# 1970 Corvette: Service Bulletin: 1970 Corvette Folding Top Material Interference with Lid Pin Support

**Bulletin No:** 70-T-46

**Date:** Oct. 27, 1970

FIGURE 1

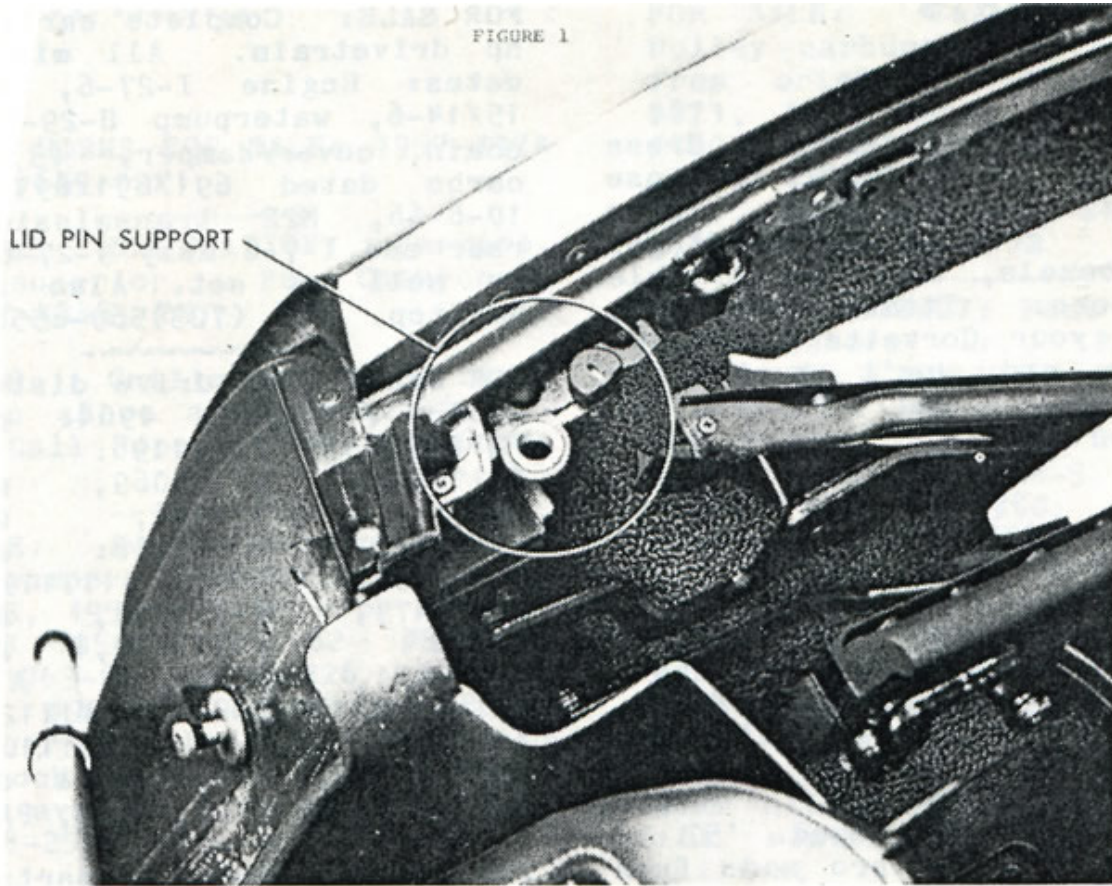
1970 Corvettes assembled prior to Serial Number S400748 may have interference between the folding top material and the top compartment lid pin support. This interference may result in damage to the folding top material.

1. Remove the lid pin support. (See Figure 1).
2. Grind 3/8" x 3/4" off the inboard edge of the support. (See Figure 2).
3. Reinstall the lid pin support and inspect to insure adequate clearance exists between the folding top material and the support.
